ARCHITECT'S ADDENDUM

Addendum Number: 01

RE: EAHS 2026 Secured Entrance

Subject: Addendum 01 to the Construction Documents for the East Aurora High School 2026 Secured Entrance Project.

A1.00

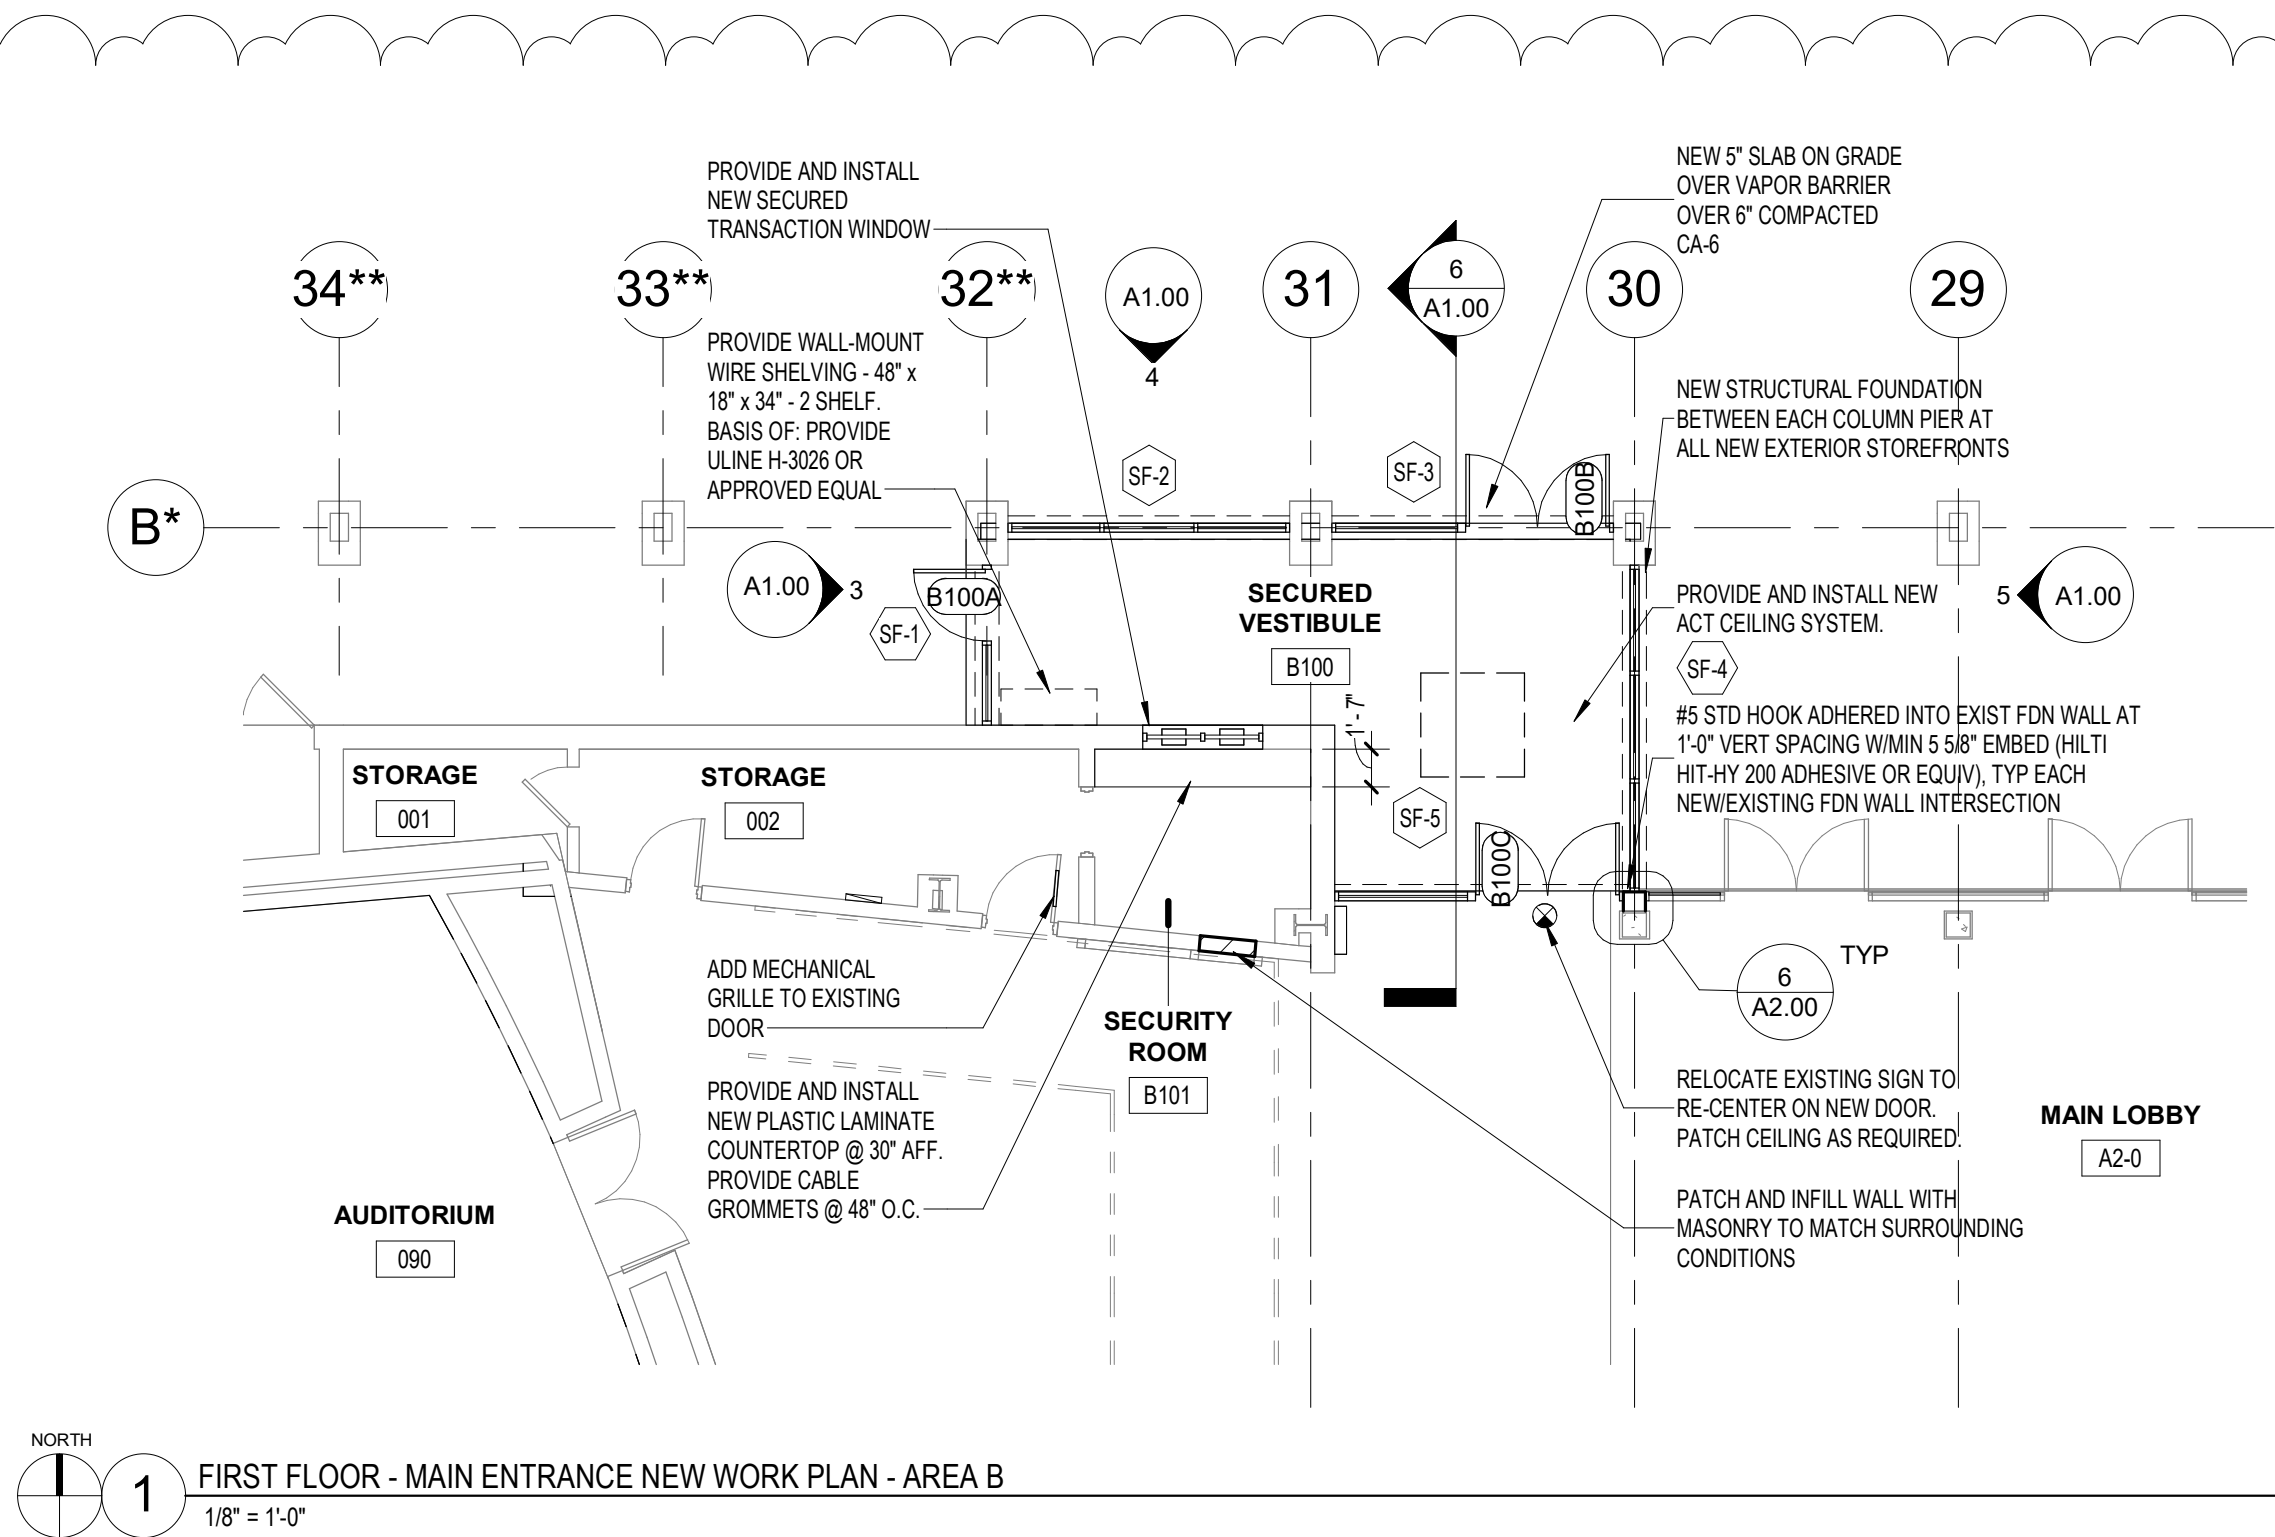
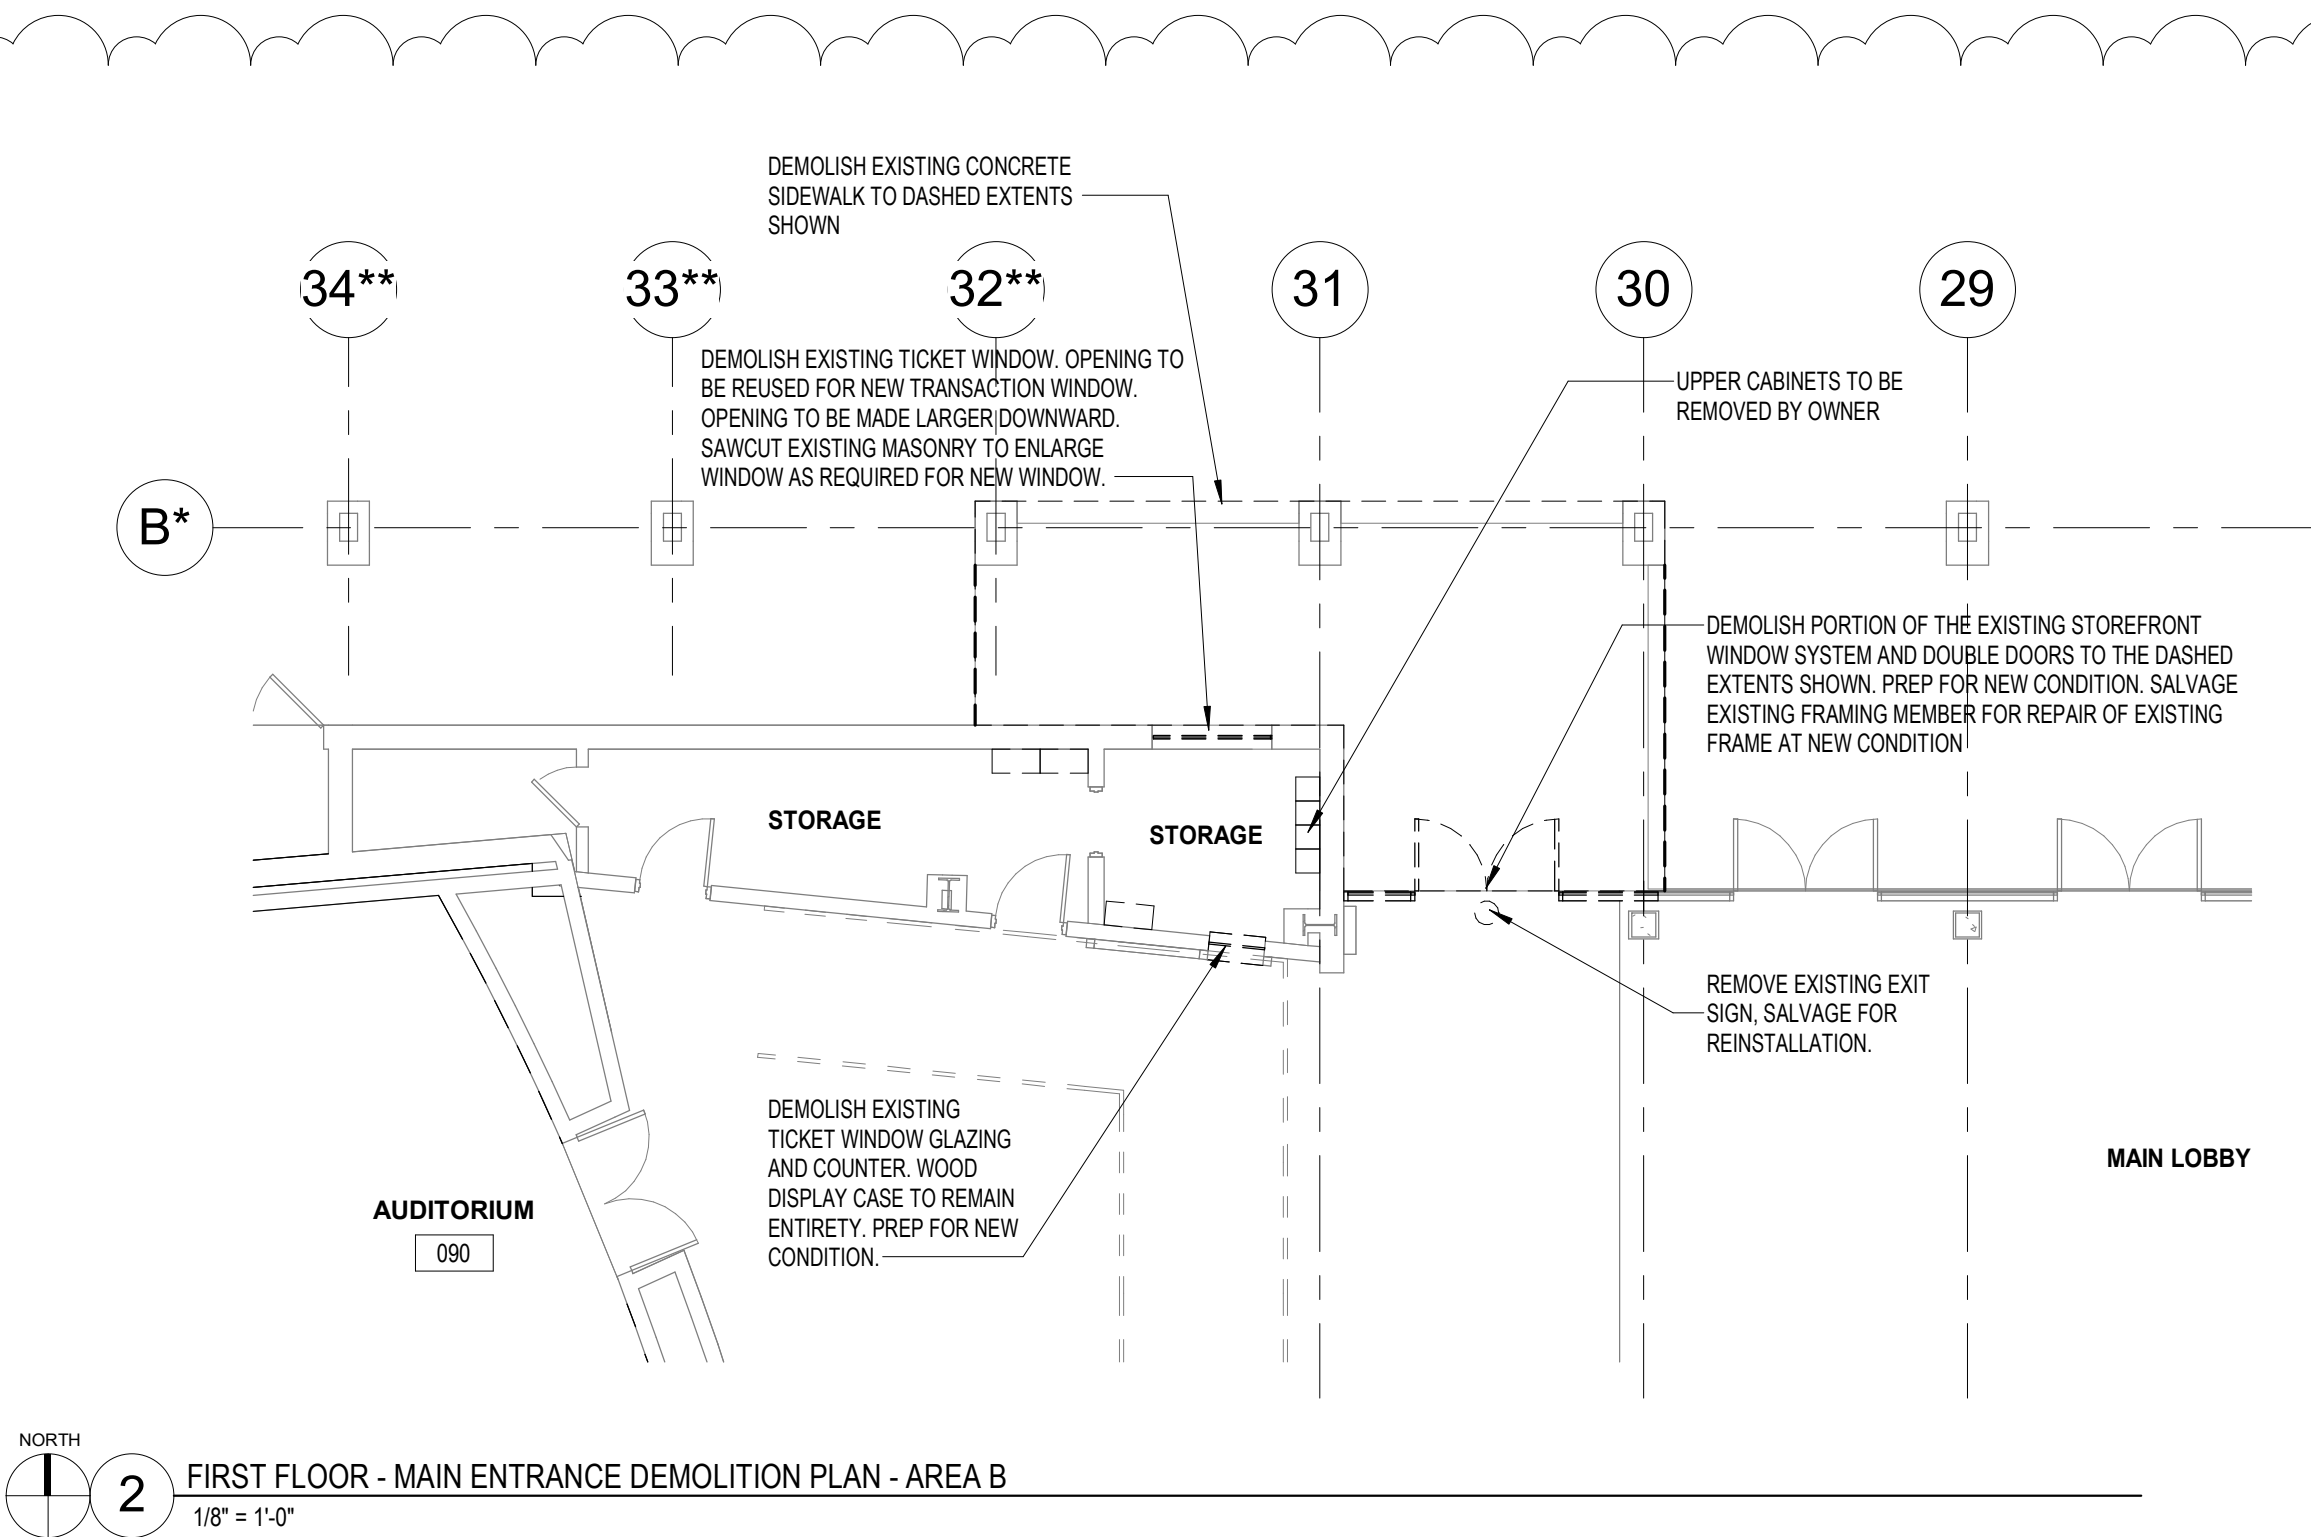
- 1) A1.00 – PARTIAL FIRST FLOOR PLANS – AREA B
 - a) Removed CMU partition dividing wall from scope of work from Plan 1/A1.00.
 - b) Removed Door 002 and Door B101A from scope of work. Door Schedule and Door Type Legend have been updated to reflect this change.

- c) Added plan note, "UPPER CABINETS TO BE REMOVED BY OWNER" on Plan 2/A1.00.
 - d) Updated demolition scope of work to existing ticket window. Revised note, "DEMOLISH EXISTING TICKET WINDOW GLAZING AND COUNTER. WOOD DISPLAY CASE TO REMAIN. PREP FOR NEW CONDITION".

- e) Removed ceiling scope of work from Storage Rooms. Existing ceilings are to remain.
 - f) Removed flooring scope in Security Room B101. Existing flooring is to remain. Floor Finish Plan and Finish Material Legend have been updated to reflect this change.

- g) Updated plastic laminate countertop depth to 19".
 - h) Updated new work scope at ticket window Added Plan Note, "PATCH AND INFILL WALL WITH MASONRY TO MATCH SURROUNDING CONDITIONS".

- i) Added plan note, "PROVIDE MECHANICAL GRILLE TO EXISTING DOOR".
 - j) Revised plan note, "DEMOLISH EXISTING TICKET WINDOW. OPENING TO BE USED FOR NEW TRANSACTION WINDOW. OPENING TO BE MADE LARGER DOWNWARD. SAWCUT EXISTING MASONRY TO ENLARGE WINDOW AS REQUIRED FOR NEW WINDOW" on Plan 2/A1.00.

3 FIXED TRANSACTION WINDOW - ELEVATION
1 1/2" = 1'-0"

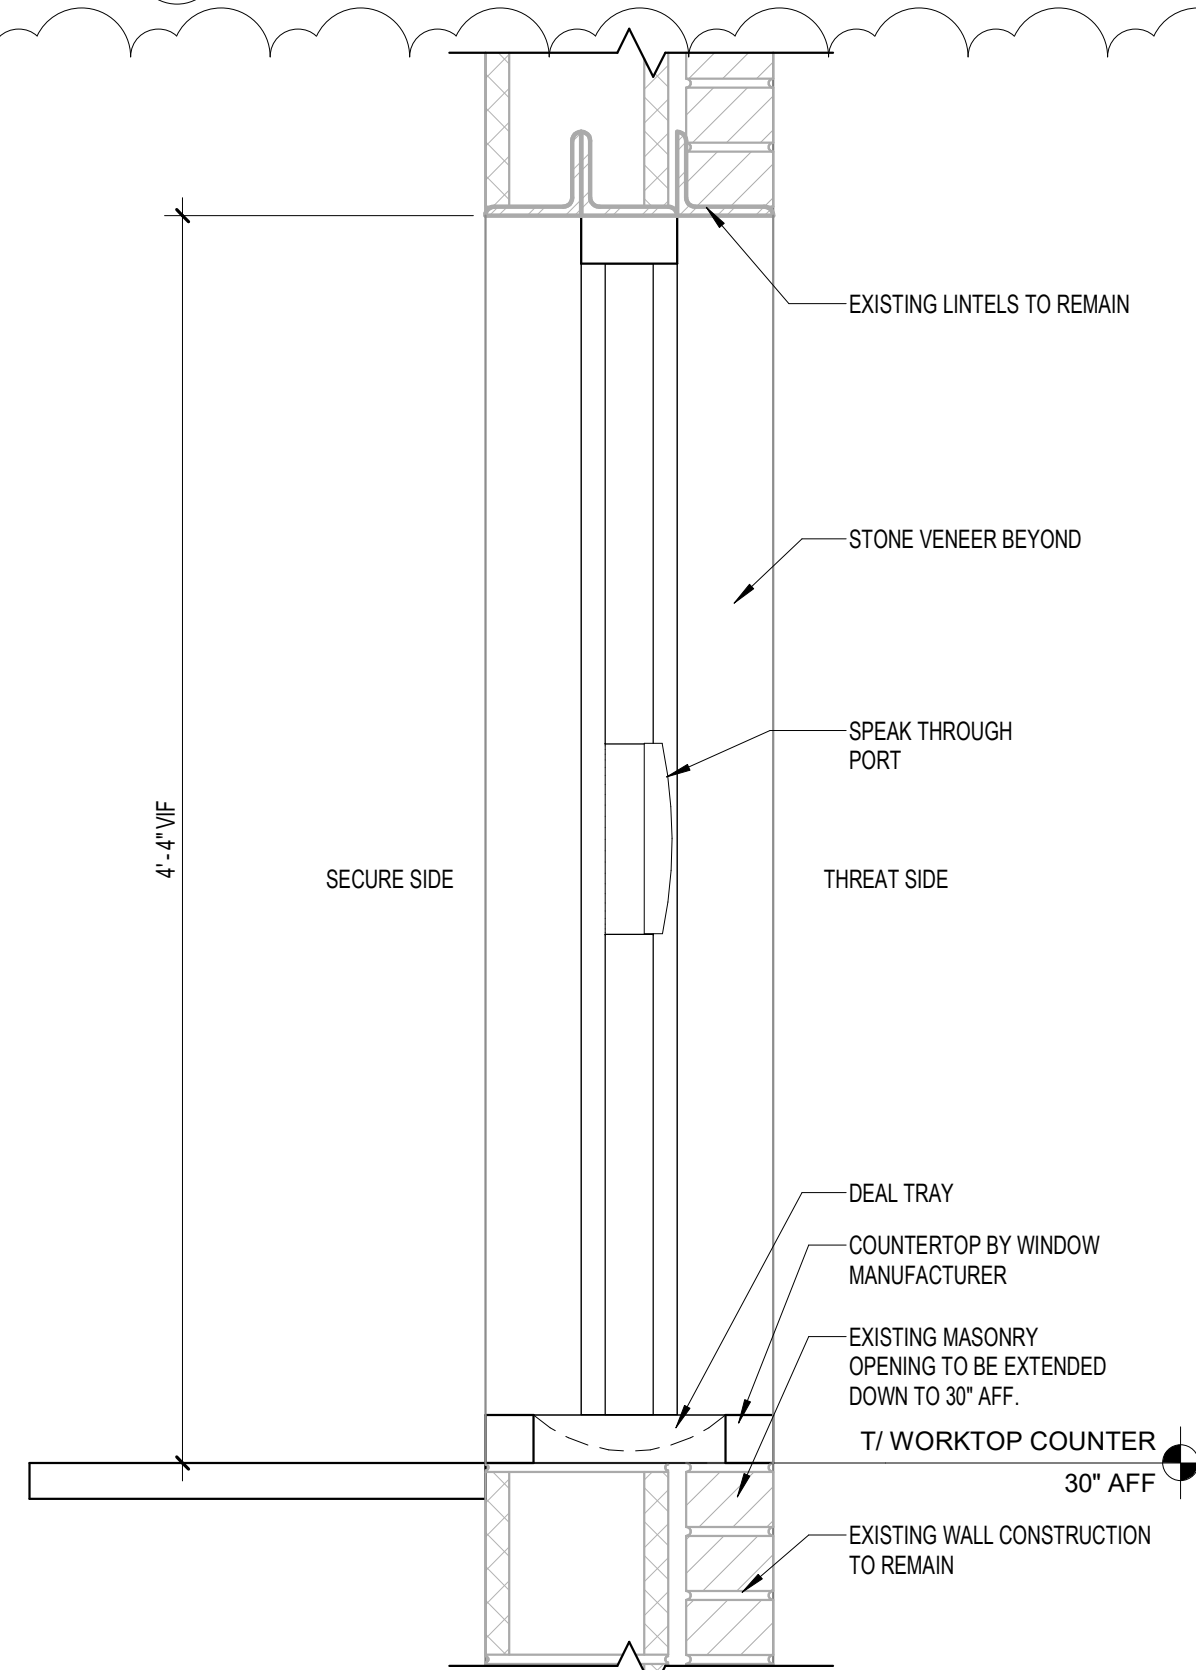
- 2) A2.00 – INTERIOR ELEVATIONS, STOREFRONT ELEVATIONS, WALL TYPES, & DETAILS
 - a) Adjusted the height of transaction window on Elevation 3/A2.00.
 - b) Adjusted top of worktop counter to 30" AFF on Section 2/A2.00.
 - c) Added note to Fixed Transaction Window Section, "EXISTING MASONRY OPENING TO BE EXTENDED DOWN TO 30" AFF".
 - d) Added dotted line region showing extend of masonry demolition on Elevation 3/A2.00.
 - e) Added note to Transaction Window Elevation, "DEMOLISH EXISTING MASONRY DOWN TO NEW HEIGHT TO ACCOMMODATE NEW WINDOW AS DRAWN".
